TO: Design Advisory Board
FROM: Scott Gustin
DATE: July 22, 2014
RE: 14-1320CA, 10 University Place

Request: Demolition of Chittenden, Buckham, Wills residential complex with redevelopment plans including Green Mountain walkway and associated pedestrian amenities

PROJECT: Demolition of Chittenden-Buckham-Wills Residential Complex
University of Vermont, 71,73,79 Colchester Avenue

LI.I

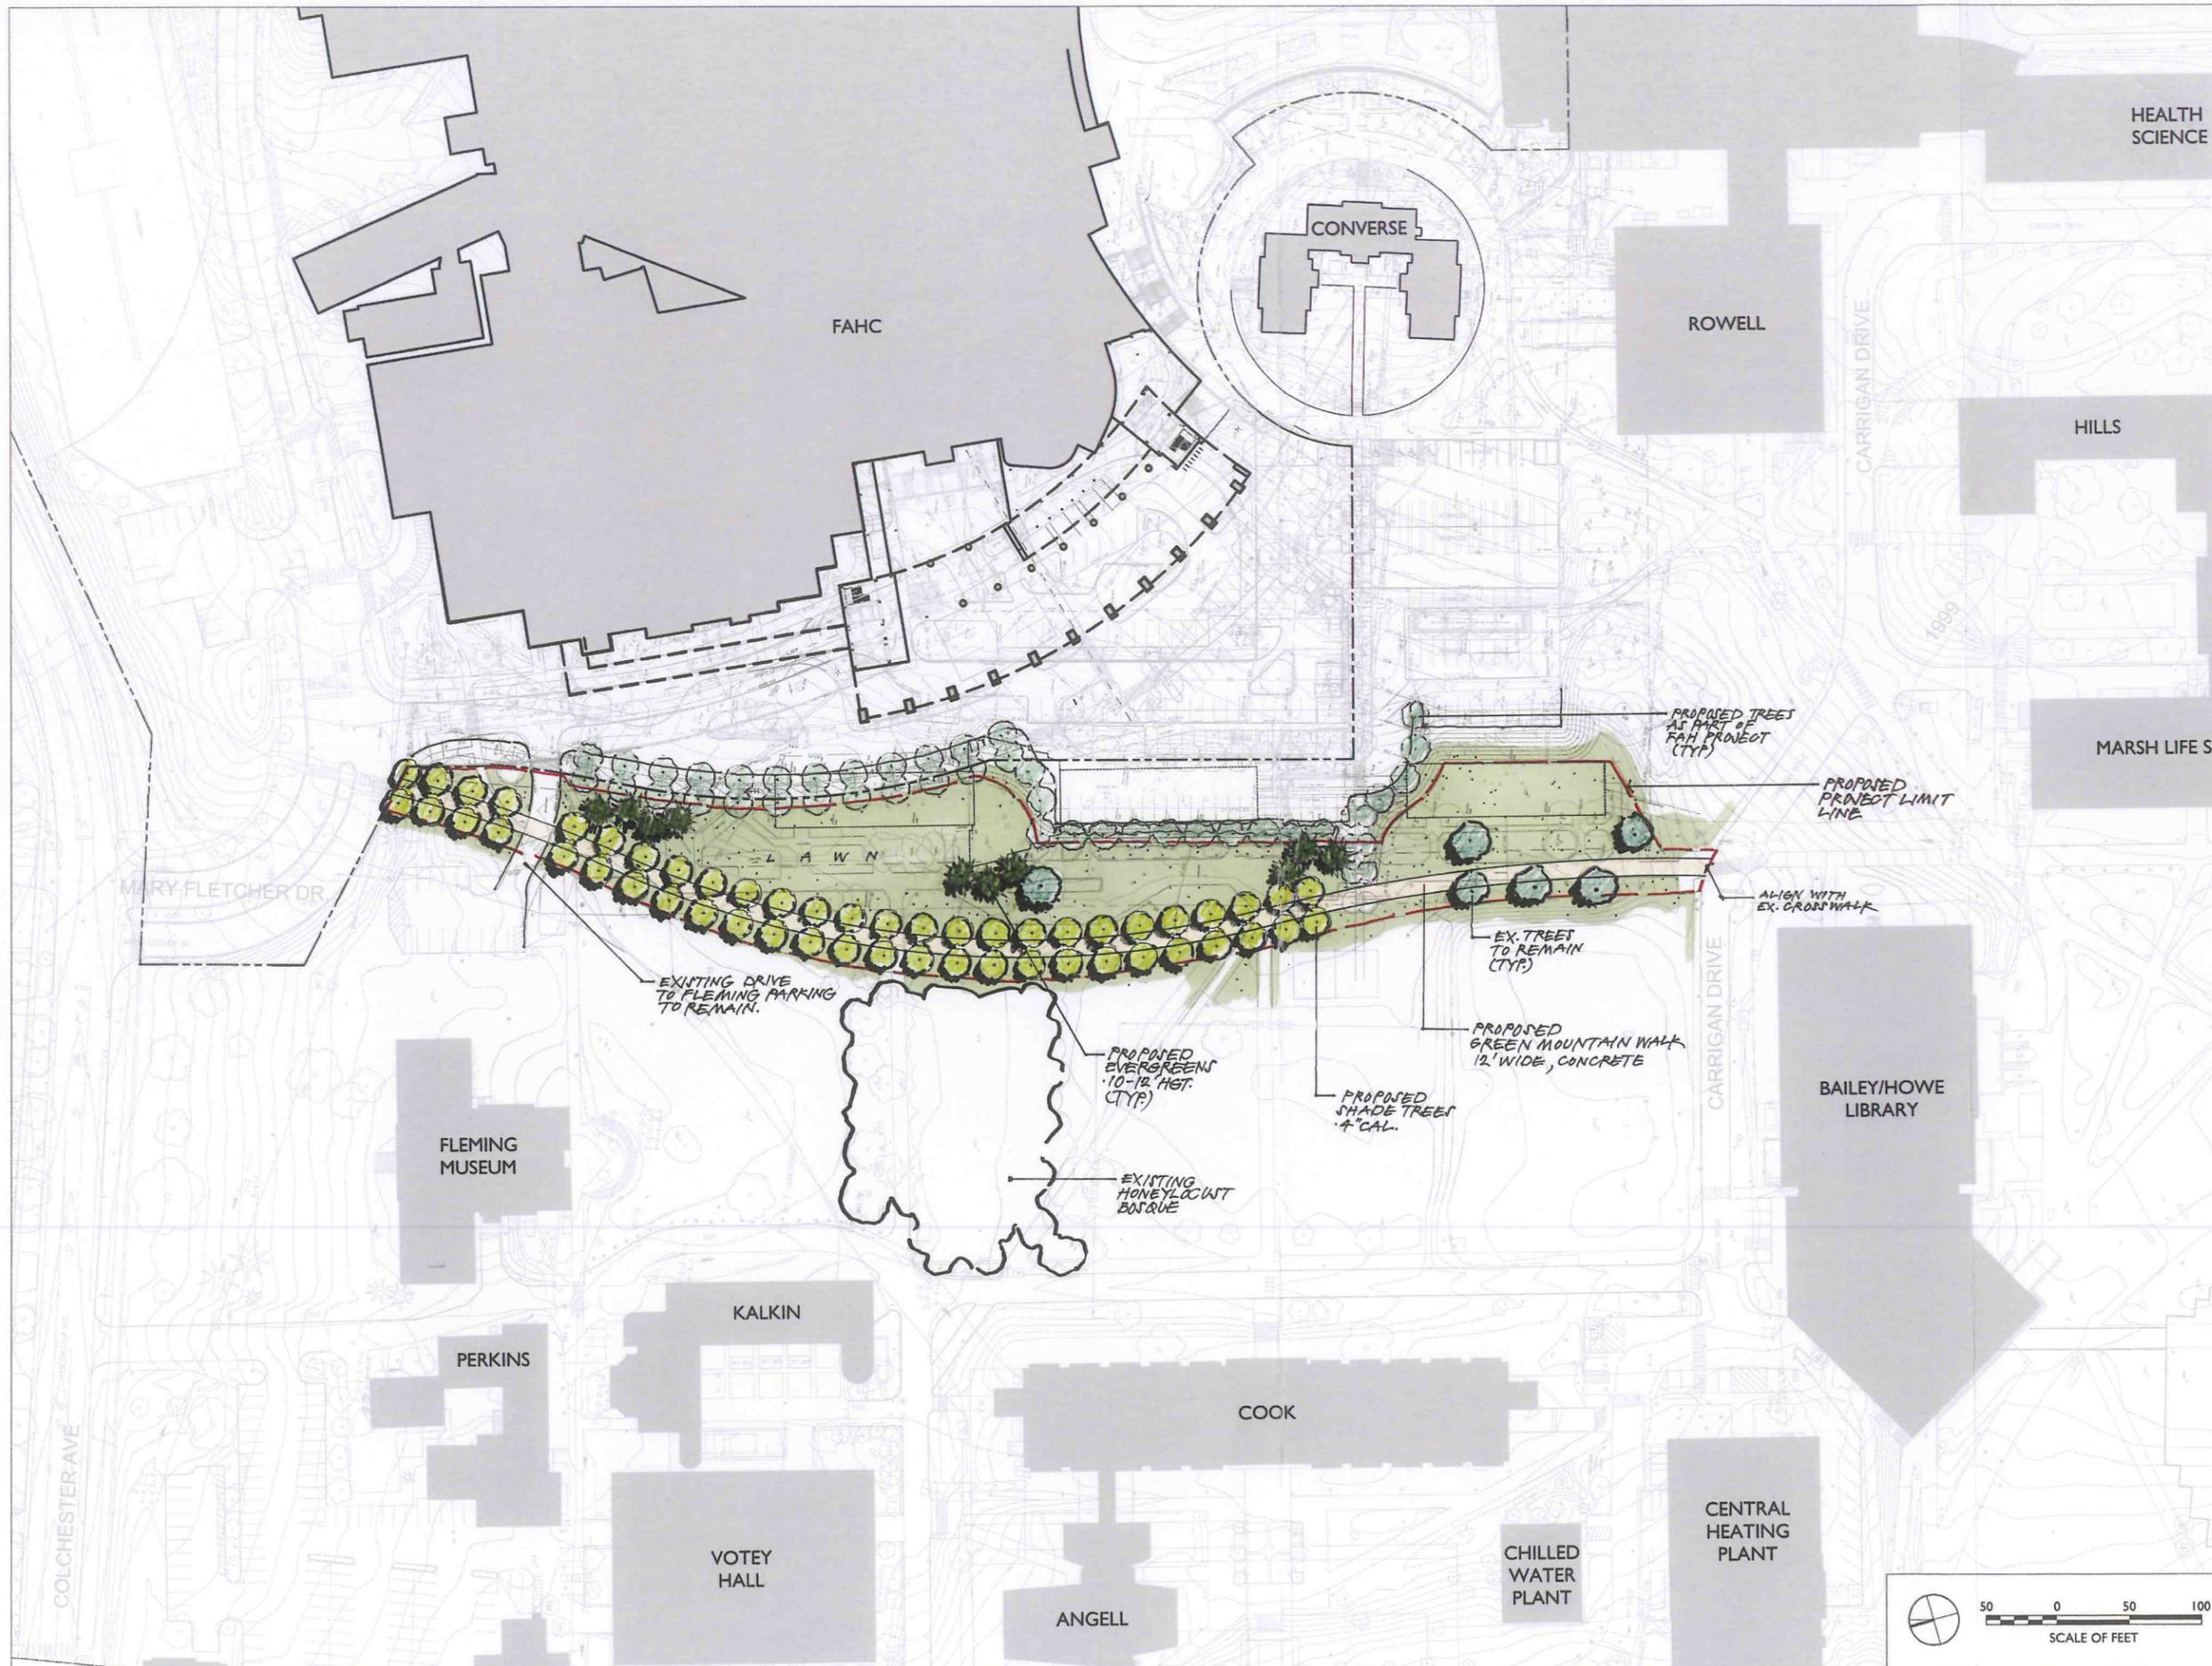
No net change in the amount of existing parking is included in this proposal. The application indicates that some existing spaces will be reconfigured to accommodate the FAHC inpatient project. How and where this reconfiguration will take place is not clear on the project plans and must be specifically identified.

New construction included in this proposal is limited to the so-called Green Mountain Walkway and associated landscaping. The proposed walkway will provide a curvilinear pedestrian link between Mary Fletcher Drive and Carrigan Drive, running through the ample green space of the central campus. The walkway will be lined with shade trees. Several clusters of new evergreen trees are also proposed. Note that the application plans refer to "conceptual redevelopment," and landscaping specifics are lacking. Details as to the type of new plantings proposed and walkway materials are needed.

No outdoor lighting information has been provided. Presumably, new lighting fixtures will illuminate the proposed Green Mountain Walkway. If so, fixture cut sheets, locations, and illumination levels need to be specified.

1. A landscaping plan that includes details as to species and size of plantings proposed.
2. Outdoor lighting fixture locations, cut sheets, and illumination levels.
3. Site plan depicting how and where existing parking will be reconfigured with no net change in parking spaces provided.
